ISSAQUAH TERRACE

ROAD, GRADING AND UTILITY PLANS

CITY OF ISSAQUAH
APPROVED
ALL WORK SUBJECT TO FIELD INSPECTION
w/conditions

ALIGNMENT AND A.R.T. PLAN

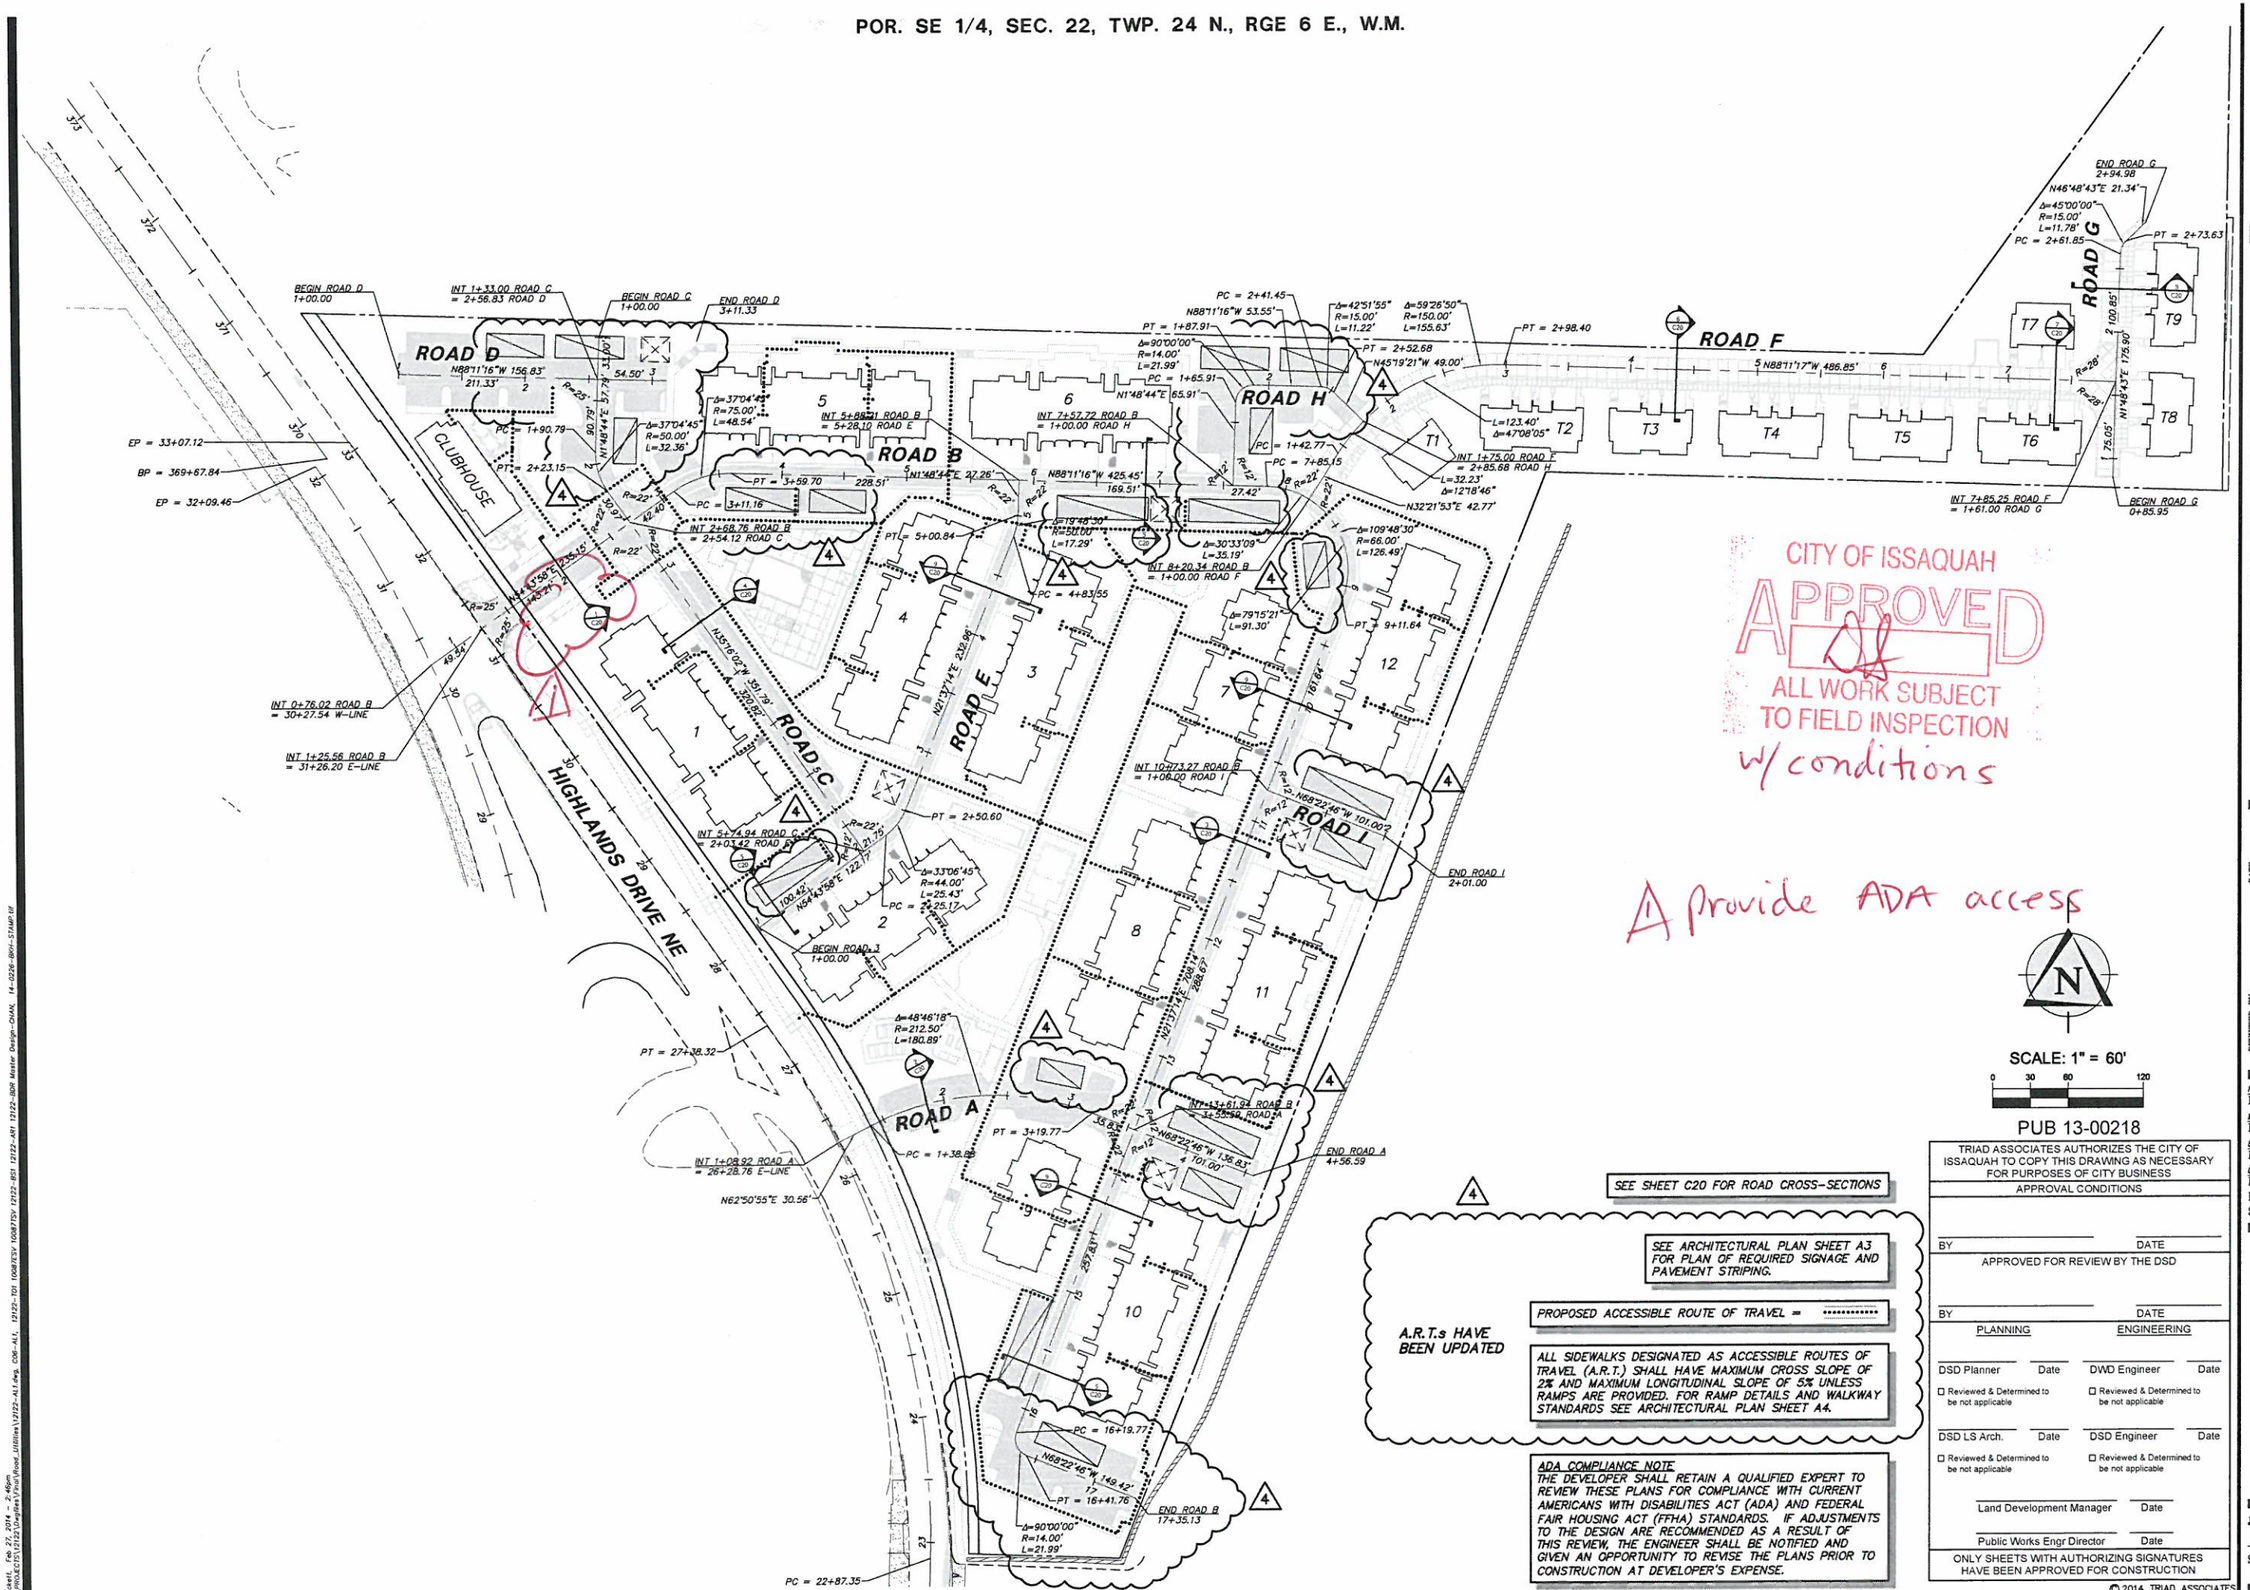
A provide ADA access

COMPOSITE UTILITY PLAN

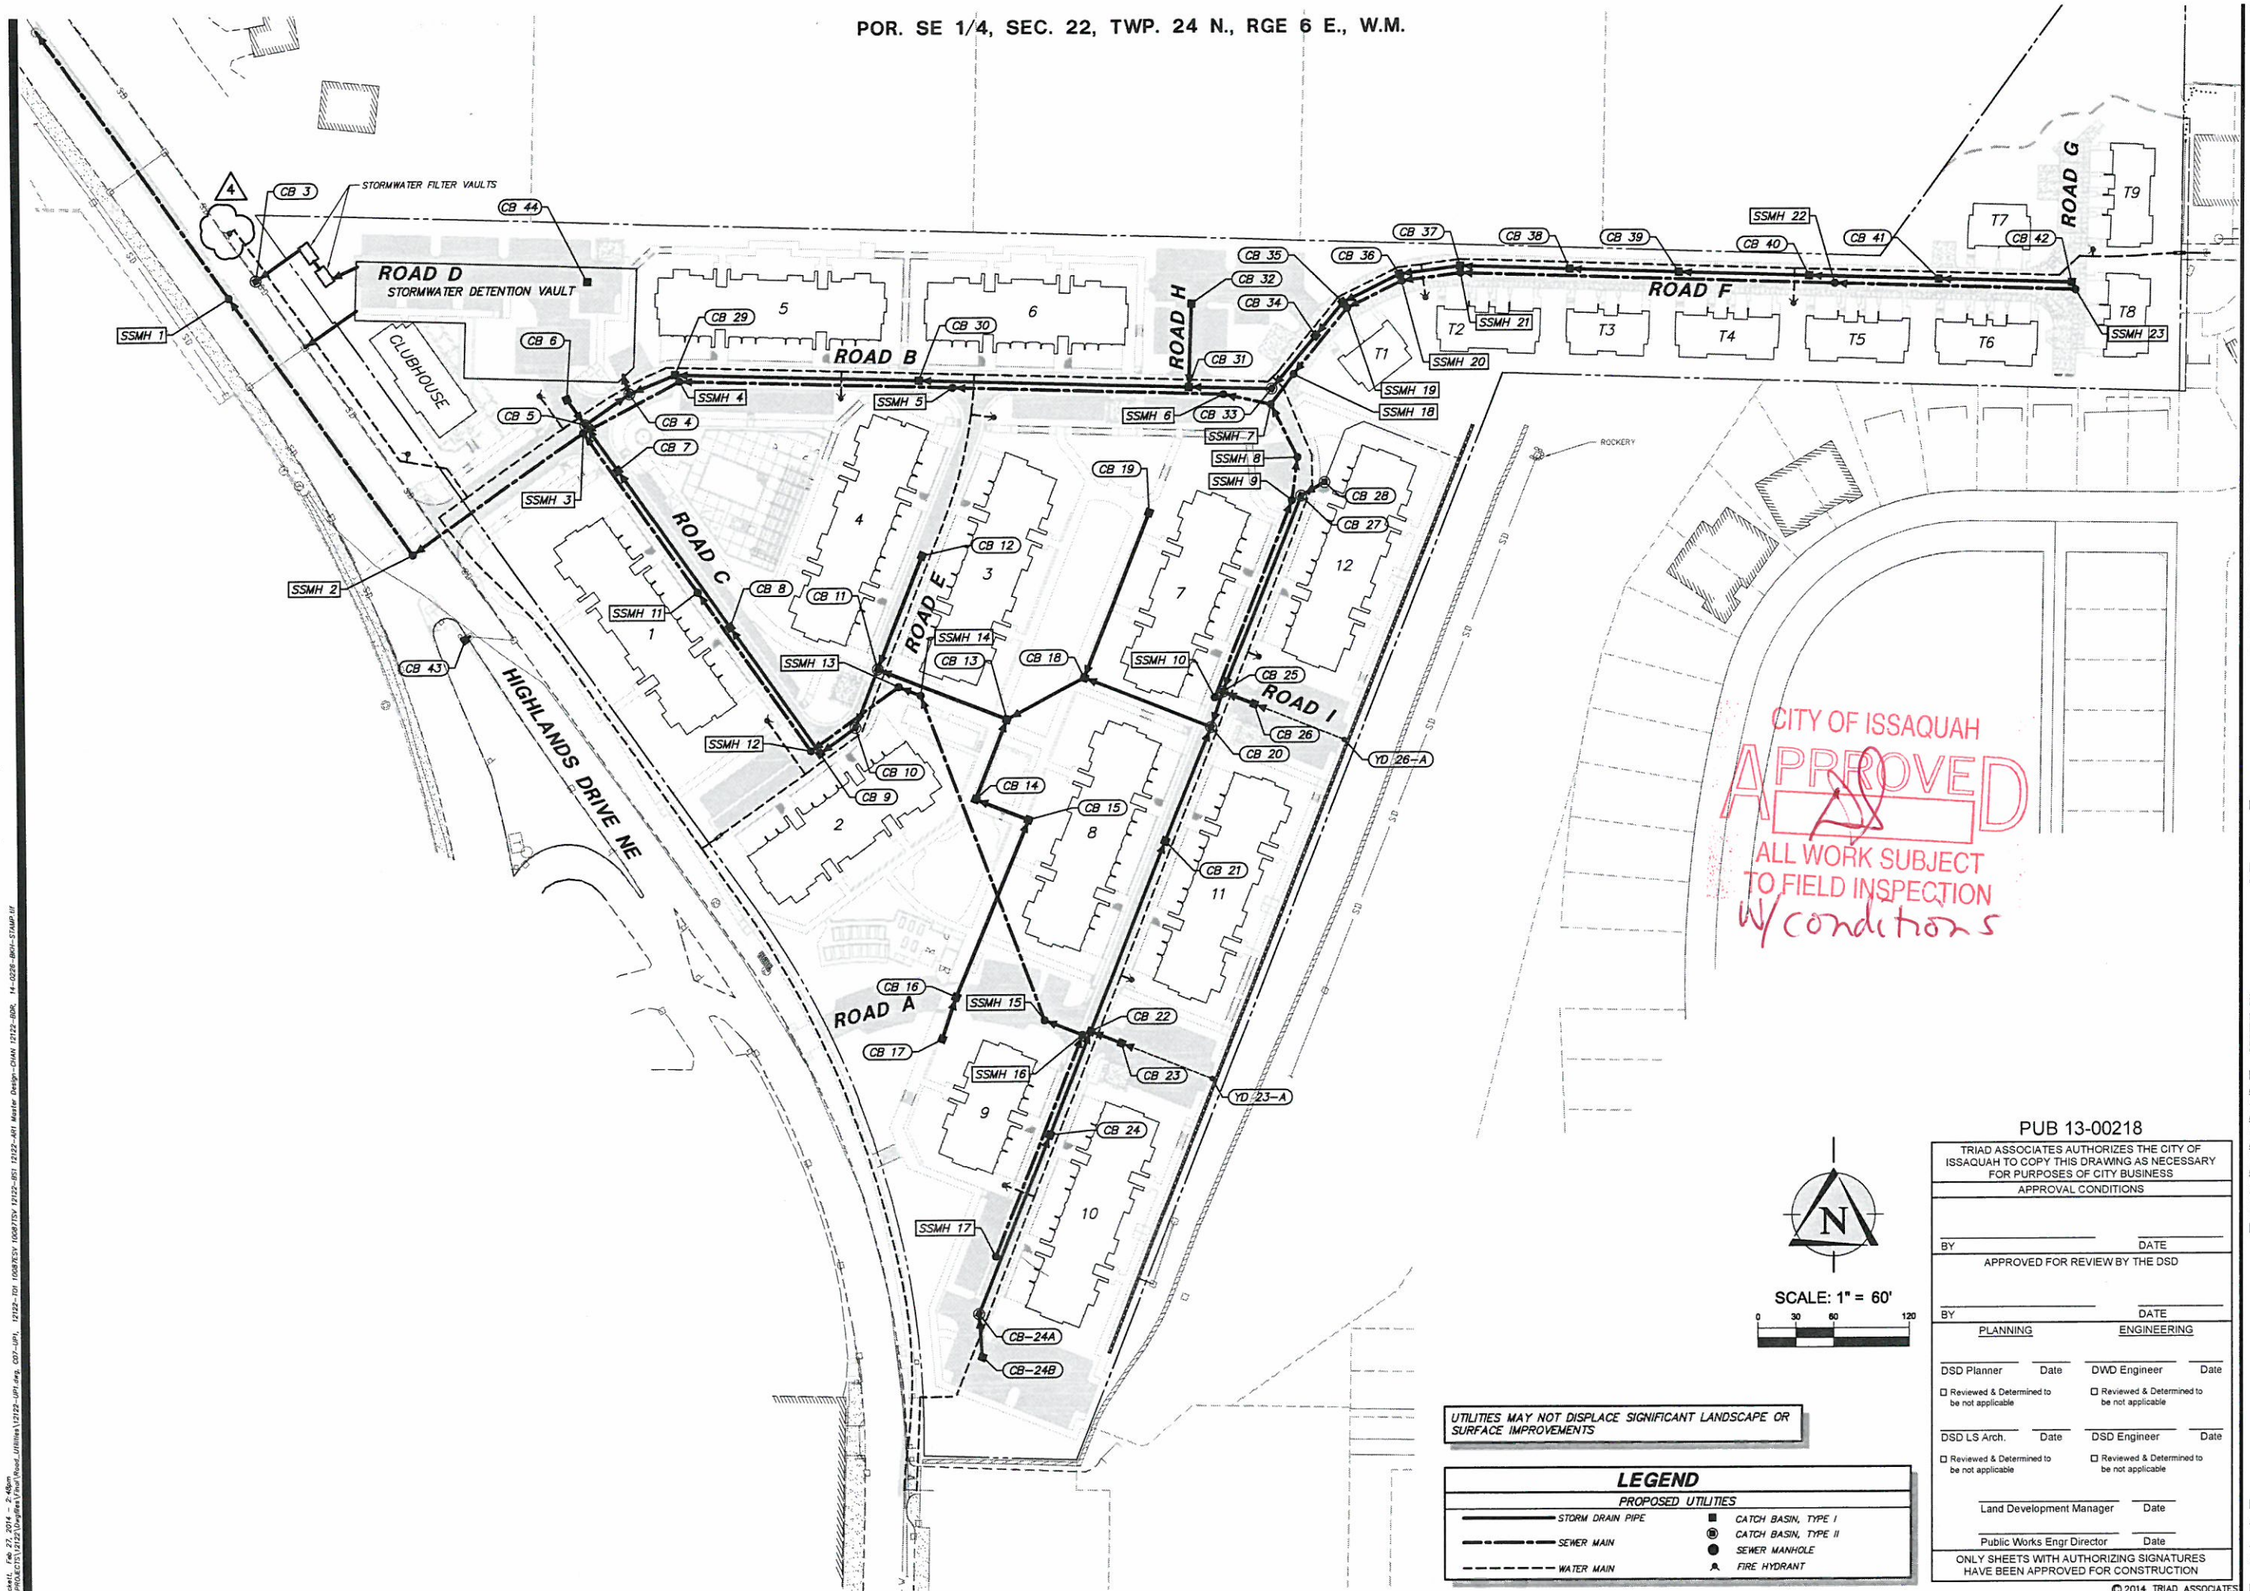
UTILITIES MAY NOT DISPLACE SIGNIFICANT LANDSCAPE OR SURFACE IMPROVEMENTS

ROAD AND STORM DRAINAGE PLANS

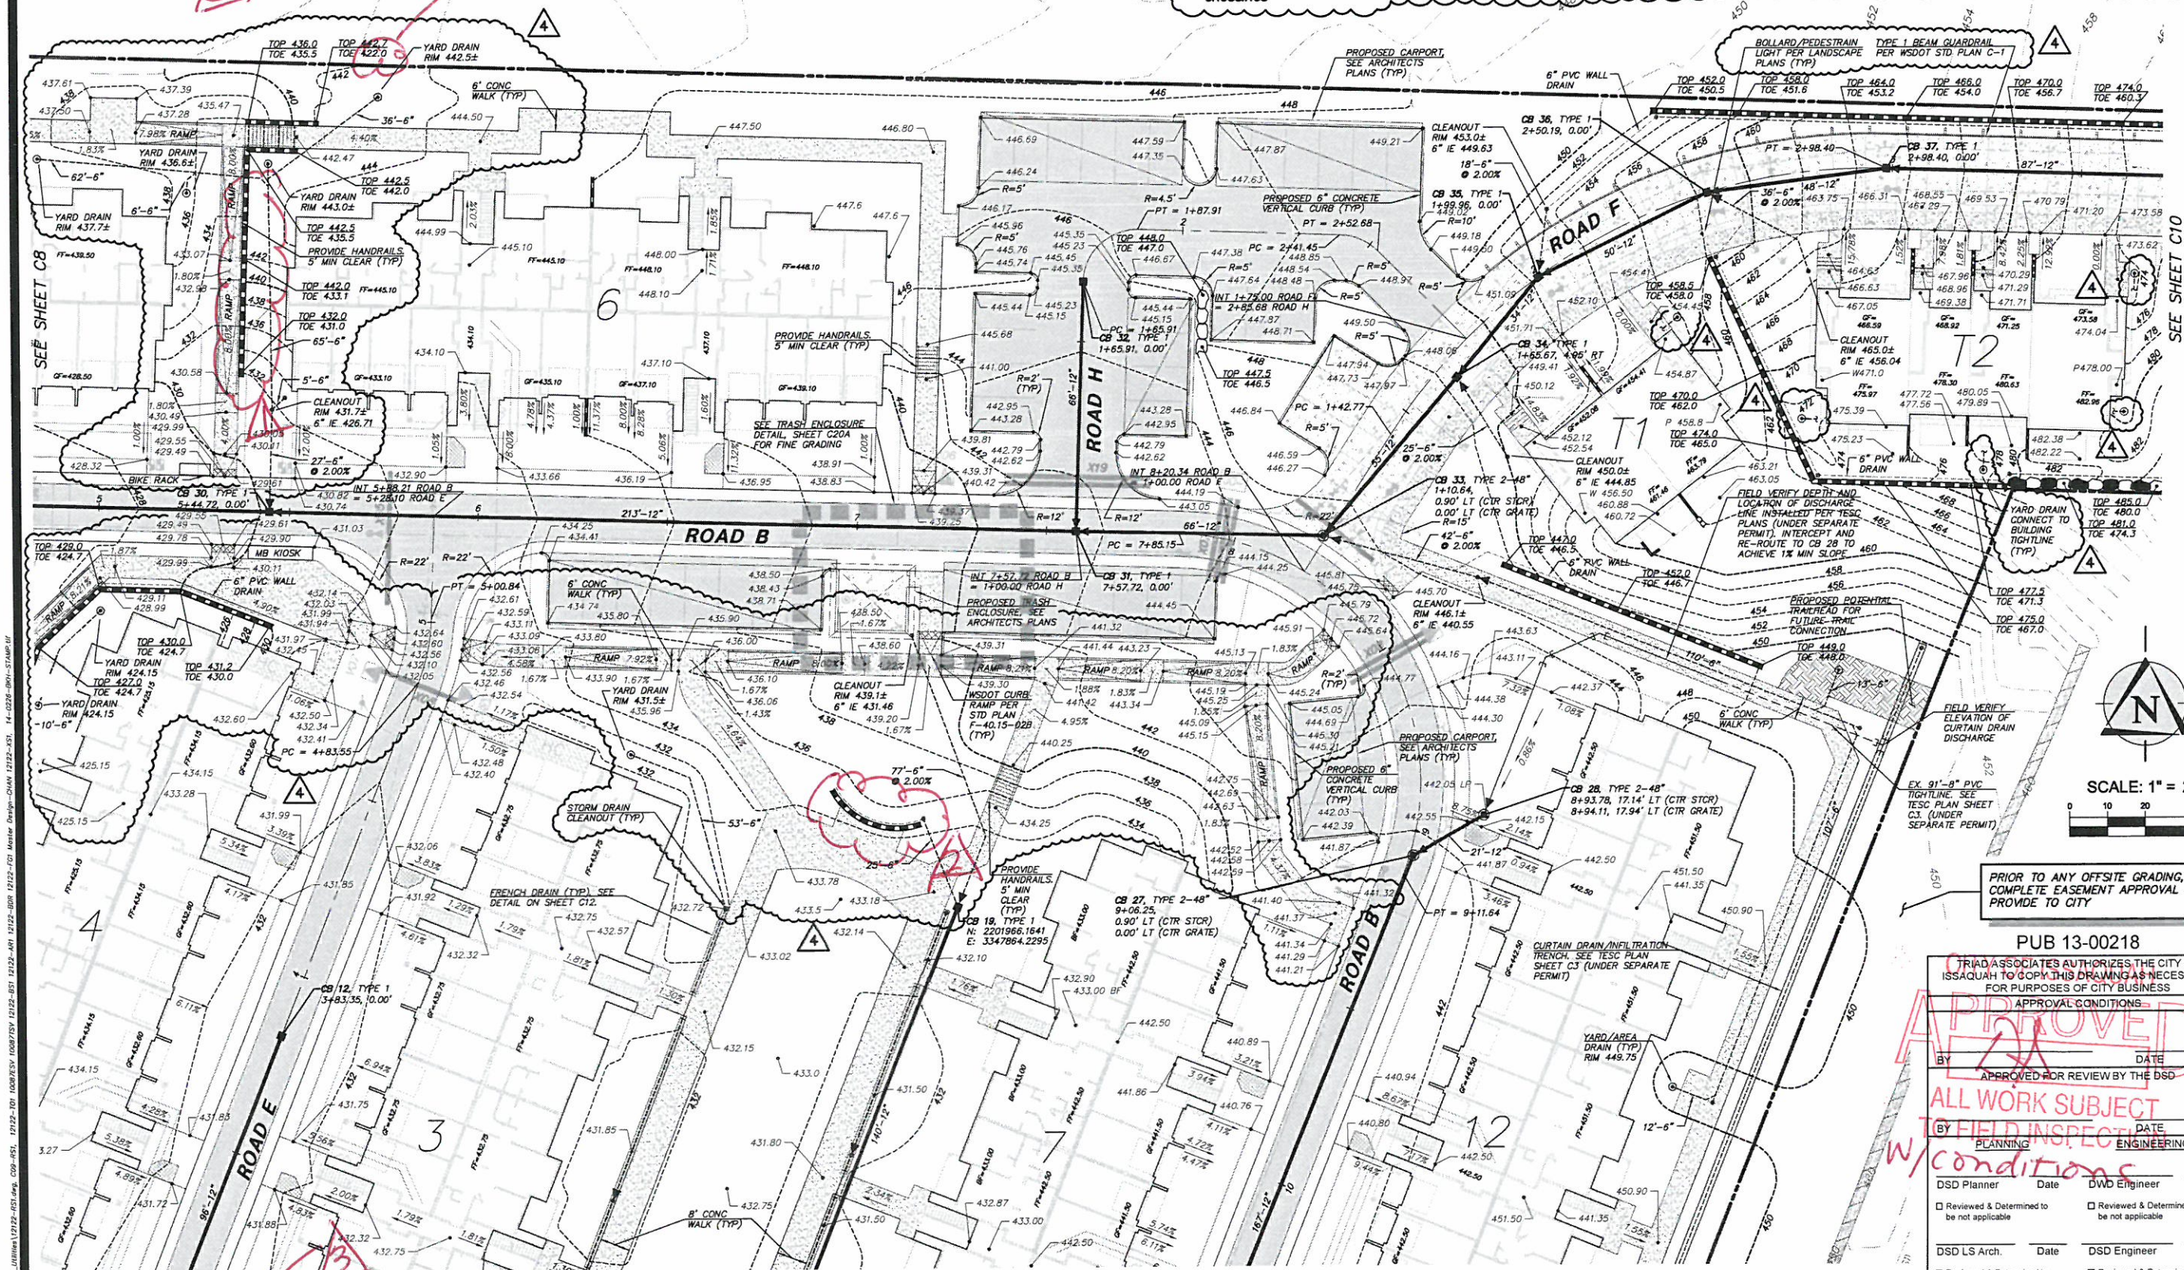
Provide 2nd wall to reduce heights of walls to less than 6 ft

Provide seat wall, 18"–24" tall

SECTION A-A
SCALE: 1" = 5'

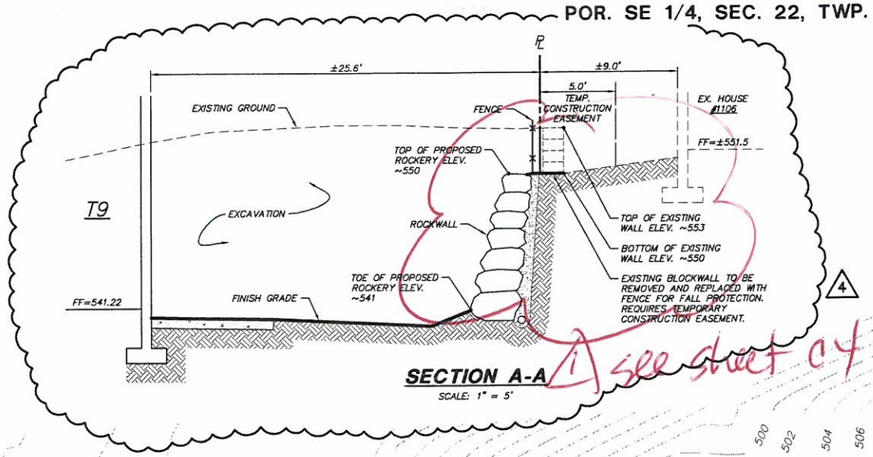
see sheet C4

1) demonstrate that planting is viable
3) see sht C8
